UNITED STATES PATENT AND TRADEMARK OFFICE

10/546,622

Office Action Summary	Application No. 10/546,622	Applicant(s) YOKOO ET AL.	
	Examiner NAISHADH N. DESAI	Art Unit 2834

DETAILED ACTION

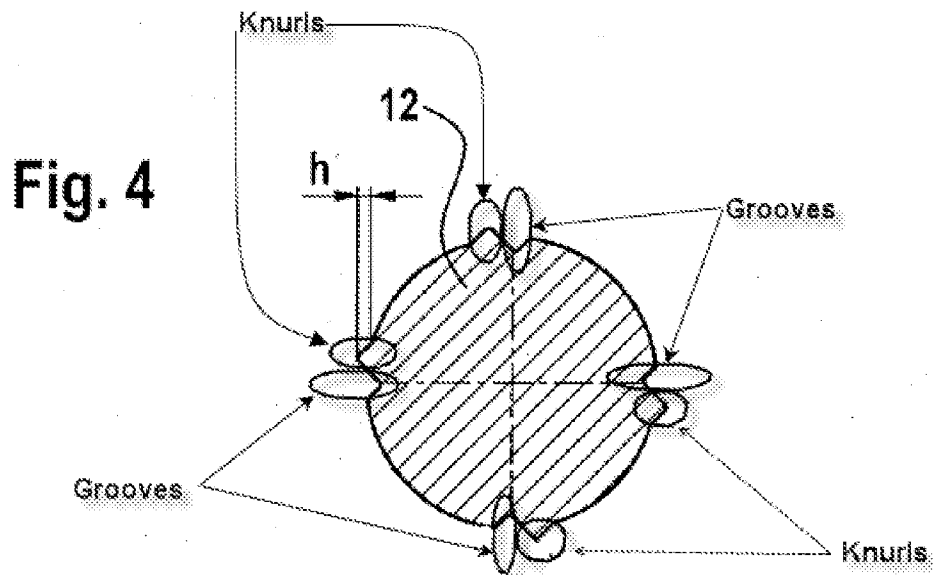
four strips of knurls (see below re-illustration of Fig 4, knurls and Fig 5,66,68,88), wherein each strip of knurls (see below re-illustration of Fig 4, knurls and Fig 5,66,68,88) is formed on an outer circumferential surface of the shaft (Fig 4,12) as to extend along an axial direction (Fig 5,66,68,88 also paragraph [00430]),

wherein the strips of knurls (see below re-illustration of Fig 4, knurls and Fig 5,66,68,88) are evenly spaced circumferentially about the shaft (Fig 4,12) as measured from a vertex of the acute-angled triangles of each knurl (see below re-illustration of Fig 4, knurls shows it having a triangular shape and a vertex).

wherein a pair of groove portions (see below re-illustration of Fig 4, grooves) is formed between a first adjacent pair of knurls (see below re-illustration of Fig 4, knurls) at each position substantially adjacent to those knurls (see below re-illustration of Fig 4, knurls) and another pair of groove portions (see below re-illustration of Fig 4, grooves) is formed between a second adjacent pair of knurls at each position substantially

wherein the vertexes (see below re-illustration of Fig 4, knurls shows them having a vertex) protrude radially outward from the outer circumferential surface of the shaft (Fig 4, 12) and the groove portions (see below re-illustration of Fig 4, grooves) sink radially inward from the outer circumferential surface of the shaft (Fig 4, 12), and

wherein the outer circumferential surface of the shaft (see below re-illustration of Fig 4 shows the shaft 12 having an outer circumferential surface which is the space between the grooves) is placed between each pair of groove portions (see below re-illustration of Fig 4, grooves) and the first adjacent pair of knurls and the second adjacent pair of knurls (see below re-illustration of Fig 4, knurls)".

5. Regarding claim 9, Frey et al (see above re-illustration of Fig 4, knurls) teaches that each strip of knurls is spaced from each other with the outer circumferential surface of the shaft.
